SUBJECT: VARIANCE / URBAN GROWTH AREA PRELIMINARY DECLARATION /
CLASS 3 SITE PLAN REVIEW / CLASS 2 DRIVEWAY APPROACH
PERMIT CASE NO. VAR-UGA-SPR-DAP21-02
3100 BLOCK OF LANCASTER DRIVE SE - 97317
AMANDA NOS. 21-104994-ZO, 21-10495-LD, 21-104996-RP & 21-
104997-ZO

Summary: Development of a new gasoline service station with 16 fueling positions and convenience store approximately 5,160 square feet in size.

United Market & Gas Station

SITE PLAN REVIEW

A1.01

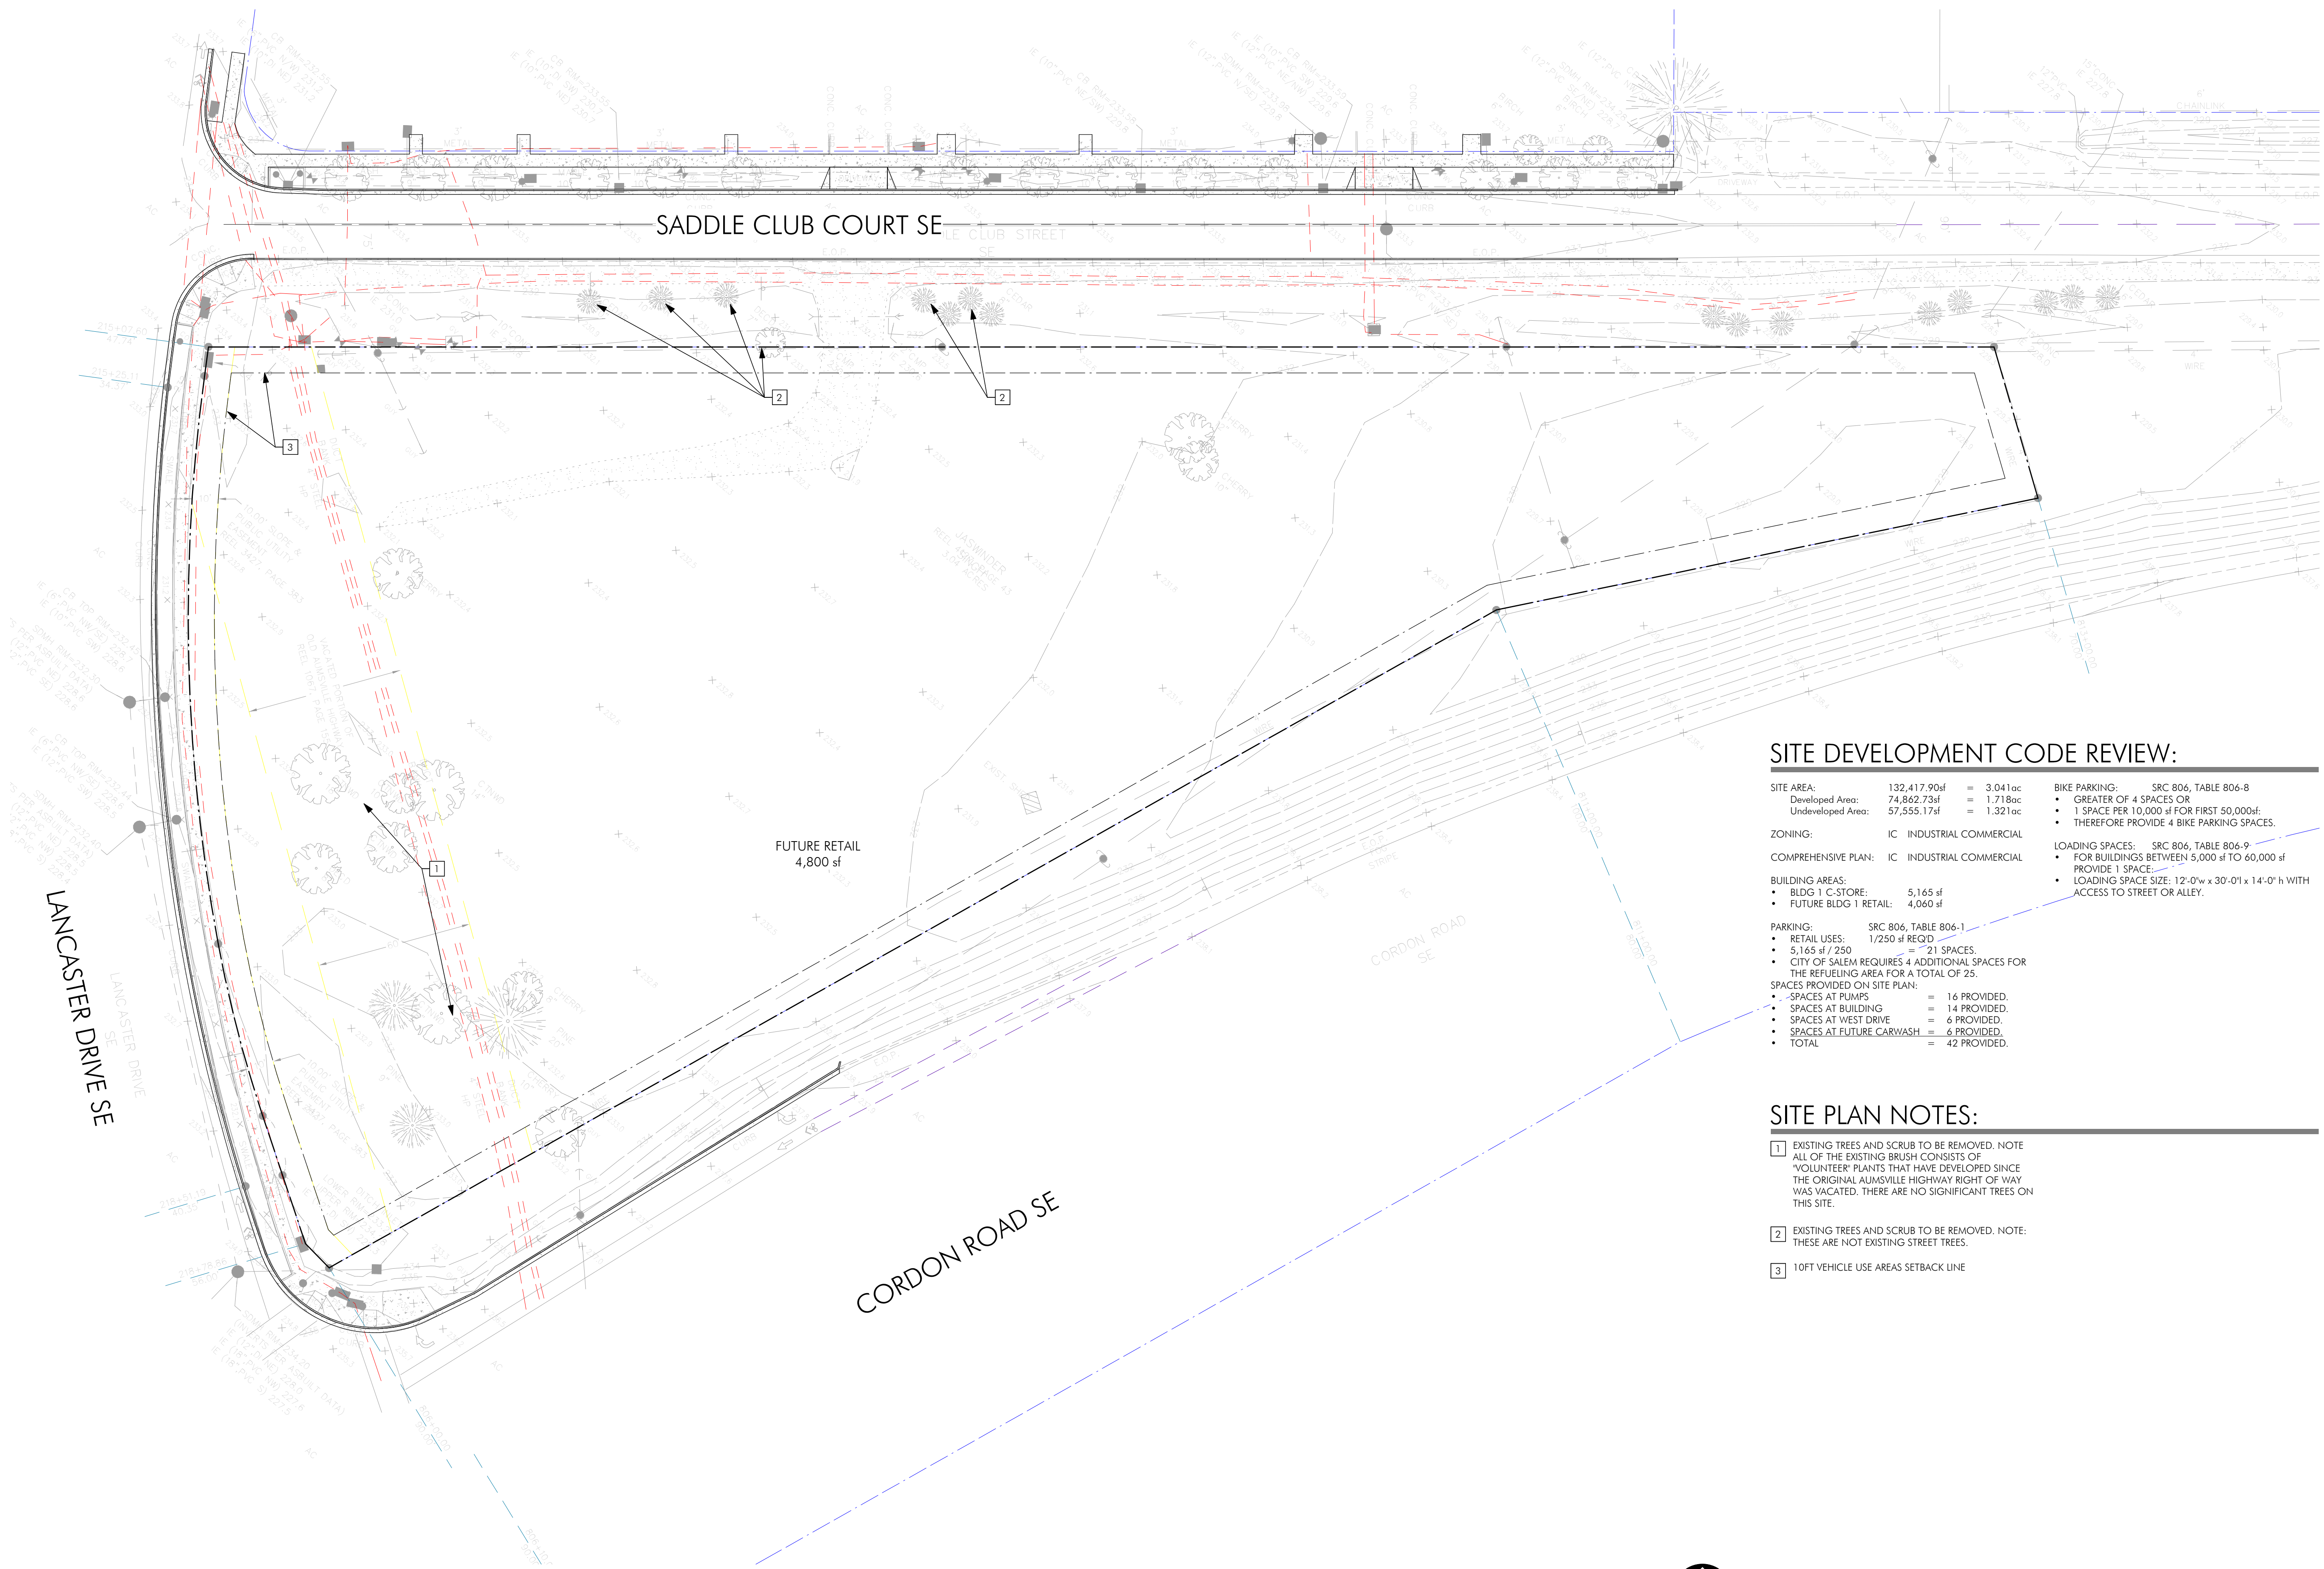
Finding: Direct pedestrian access is provided from the proposed convenience store to Saddle Club Street SE and to Lancaster Drive SE. The proposed site plan does not show a pedestrian connection to Cordon Road SE, however, as specified in the conditions of approval, an interim sidewalk will be constructed along the frontage of Cordon Road SE to a location perpendicular to the convenience store. The pedestrian pathway will be required to extend to the new sidewalk on Cordon Road SE to connect the building entrance with this street frontage.

Finding: The application materials do not indicate how the walkway will be visually differentiated from parking areas and drive aisles. This section requires the walkway to be differentiated from the vehicle use area through the use of elevation changes, a physical separation, speed bumps, different paving material, or other similar method. Prior to building permit issuance, the applicant shall provide evidence that where a proposed walkway crosses a parking area or drive aisle that the walkway will be visually differentiated as required by this section.

Finding: The proposal appears to comply with the minimum interior landscaping requirements of this section, however the summary table on the proposed site plan does not indicate the size of the proposed parking area and does not indicate the amount of interior landscaping provided. Prior to building permit issuance, the applicant shall update the summary table to indicate the size of the parking area and the amount of interior landscaping provided, noting compliance with the minimum standard of this section.

Finding: The site plan shows that two staple style bicycle parking racks will be installed on a concrete pad that is six feet in depth and eight feet in width, providing adequate space for four bicycle parking spaces. A four-foot-wide access aisle is provided directly behind the bicycle parking spaces in compliance with this section.

- *A minimum of 25 off-street parking spaces are required for the proposed development. The proposed site plan indicates that 14 spaces are provided, with additional room for parking under the fueling canopy. Spaces provided in the fueling canopy are not counted as off-street parking spaces in Chapter 806. The proposal does not comply with the minimum off-street parking requirement.*

Please either revise the site plan so that the minimum off-street parking requirement is met, or alternatively, the applicant may request an adjustment to reduce the amount of off-street parking spaces required for the proposed development. With the understanding that a portion of the traffic generated for the convenience store are by trips to the gasoline service station, with customers leaving their car to be filled at the pump while making quick trips to the convenience store, staff would likely be supportive of an adjustment. The burden is on the applicant to demonstrate that an adjustment request fully complies with the approval criteria established in SRC Chapter 250.

No bicycle parking spaces shown on the proposed development plans.

- *The proposed plans should be revised to include information on proposed bicycle parking, noting compliance with the minimum bicycle parking requirement established in SRC 806.055 and the development standards established in SRC 806.060*

Condition 1: A pedestrian pathway shall extend from the entrance to the proposed convenience store to the interim sidewalk on Cordon Road SE.

Condition 2: Prior to building permit issuance, the applicant shall provide evidence that where a proposed walkway crosses a parking area or drive aisle that the walkway will be visually differentiated as required by SRC Chapter 800.

The Site Plan has been revised to show a total 42 parking spaces, consisting of 16 spaces on the refueling pad and 26 spaces elsewhere on the site. Based on the provision of 42 spaces, we have increased the number of accessible spaces to 2.

Per the note on the site plan, it was always intended that 4 bicycle parking spaces would be provided. They are shown on the revised site plan.
